ROTHER VALLEY RAILWAY  
ROBERTSBRIDGE

PUBLIC FOOTPATH,  
FOOTPATH AND  
BRIDLEWAY CROSSINGS

**Subject:** Doc 4 B - Annex B. "Correspondence with Local Horse riders representative".

## **Rother Valley Railway - Annex G. Bridleway Crossing, Risk Assessment**

PLAN OF BRIDLEWAY CROSSING  
SCALE 1:100

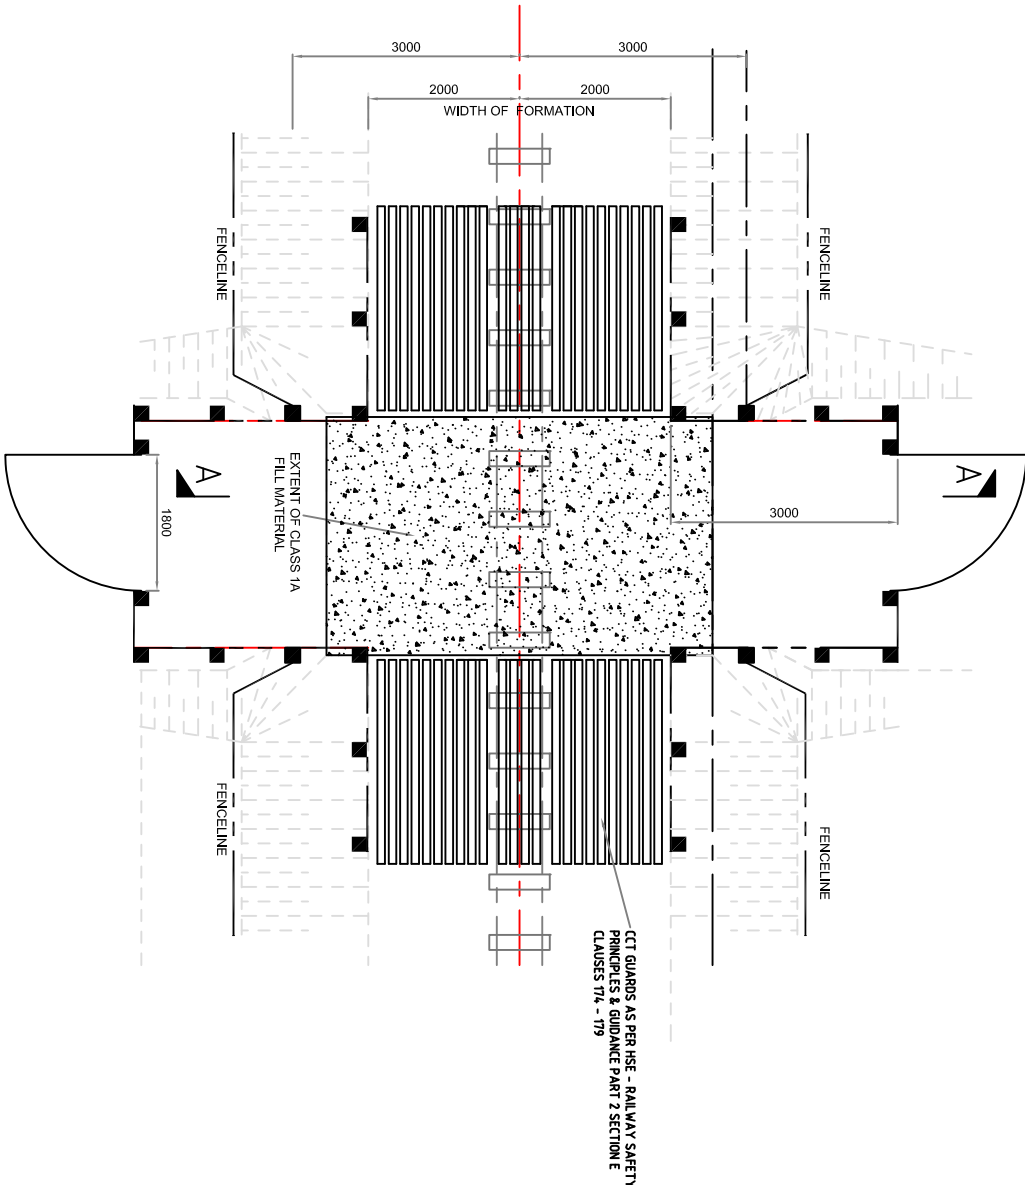
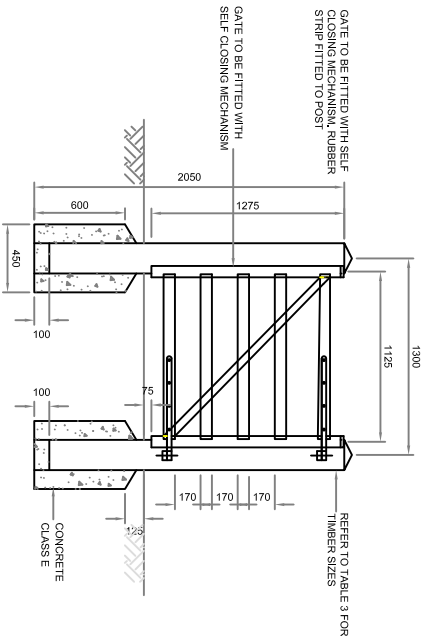
1. The fencing and surfacing within the railway side of the gate should be 1m wider on the catch side.
2. We would utilise the gate catch you suggested as detailed in your e-mail below.
3. There will be "stepped" mounting blocks at each side of the crossing, on the LHS going towards the gate.
4. The gate size proposed on the present drawing was fine.
5. The gates should not be self or hydraulic closing.
6. The new surfacing should extend at least 50m from the gates, so that the horses do not experience a change of surfacing as they pass through the gates.

With regard to the bridleway crossing, although I note your point regarding the crossings on the Welsh Highland Railway we will need to look at this from the point of view of what provision should be made for the bridleway rather than what is tolerated on other routes.

Bridleway 36 and the connecting bridleway comprise a significant length of gate free riding, which is rare in the Rother area as it is particularly poorly served by bridleways. A gated crossing would represent an unwelcome addition for riders and other users, however it is designed.

I have attached BHS guidance, which makes recommendations on things such as manoeuvring space, latches, and self-closing mechanisms. We would be looking to adhere to the BHS' standards as far as possible if gates were installed.

17. Gates or stiles normally protect these crossings. Gates should be self-closing without any latches and should open away from the railway. It is essential to provide the same facility at each side of the crossing (i.e. gates and stiles are not intermixed at one crossing, and both gates must be of the same width) so that users do not become trapped on the crossing. Miniature red stop and green lights or other active indication of an approaching train may be provided where sighting distance is limited, audible warnings may be provided at the crossing and, as a last resort, whistle boards provided to give further warning of an approaching train.
18. It should be possible for horse riders to open gates on bridleway crossings without dismounting, unless there is a risk of contact with overhead power lines."

- only open away from the track so users don't walk blithely into a different, potentially dangerous, environment and so that users spend as little time as possible on the track
- NOT have a catch that has to be operated by the user as this delays users getting off the track NB Catch-less gates can be opened in a straight line without the turning on the line side that would be needed to operate a catch
- have a clear width of at least 1.5m between the gate posts to comply with the law on bridleway gates

- be gently self-closing against the clap-post so that the long body of the horse has time to get through before the gate catches it
- stay shut in all conditions of wind and gravity so the next user realises they are entering a different, potentially unsafe, environment\*. This should be achieved mainly via the hinge mechanism but catches, such as magnets, that do not need operating can help, provided they are not too strong for an elderly or child rider to counteract easily from horseback. Weights are NOT acceptable as a closing mechanism as the horse can balk at or get caught in these and delay leaving or getting on to the track

- have 1.8m clear space for the horse's head and neck beyond the clap-post above any gate/fenceline so the swing of its head/neck is not impeded. There should be no handle sticking up from the gate

- have 4m of manoeuvring space outside the gate clear of obstructions to allow the horse to move as its rider pulls the gate open and turns to go through it. This should include enough room beyond the hinge for the horse to approach the hinge end of the gate and turn to stand parallel to it with the rider next to the clap-post, ready to pull the gate open

We are revising the drawing of the bridleway crossing to take account of our discussions and your suggestions, and I will forward it to you and Matthew shortly to check that you are content.

Dear Sarah,  
Thank you for your e-mail below.  
We of course follow ORR guidelines on all our railway work. Once the final designs are close to completion, we will of course share them with you.  
Kind regards  
David  
RVR/TWAO Project Manager
